SI M11 04 13
Engine

This Service Information bulletin supersedes SI B11 04 13 **dated November 2013**

Service Action: N14 Engine Check Timing Chain Tensioner and Timing Chain

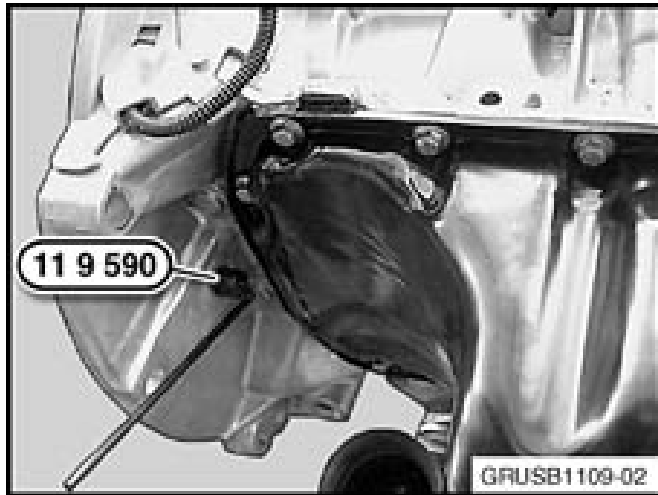
Item 1: Protruding boss – Not OK	Item 3: Drilled head – OK
Item 2: Flat head, no markings, no holes, no machined edge – Not OK	Item 4: Machined edge in head – OK

2. **NEW** If the engine is fitted with a timing chain tensioner that has a drilled head (item 3) or has a machined head (item 4), do not replace the timing chain tensioner. No further repairs are needed. If the chain tensioner has a protruding boss (item 1) or a flat head (item 2), proceed to step 3.
3. Remove the right-hand wheel arch trim to access the crankshaft central bolt.
4. Disconnect the battery and remove the ignition coils and spark plugs. Turn the engine in clockwise direction by hand to move the flywheel approximately 90° before TDC. Rotating the engine counterclockwise may cause an incorrect measurement.

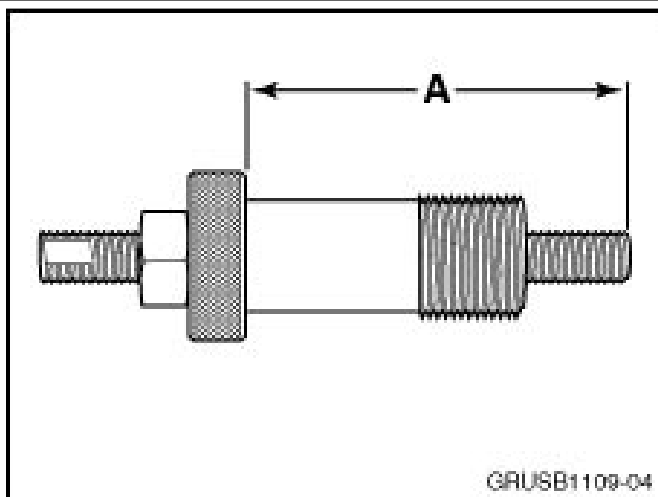
7. Remove chain tensioner Special Tool 11 9 340 from the engine, with the lock nut still tight. Measure the distance (A), as described in the illustration.

8. If distance A is less than 68 mm, replace the chain tensioner with sealing ring P/N 11 31 4 609 482 (refer to parts list A).
9. If distance A is 68 mm or greater, replace the components below, found in the Timing Chain Repair Kit P/N 11 31 8 623 601 (refer to parts list B):
 - Timing chain tensioner
 - Sealing ring
 - Timing chain
 - Guide rail
 - Tensioner rail
 - Sliding rail
 - Sprocket on the crankshaft
 - Bearing bolts for the tensioner and guide rails
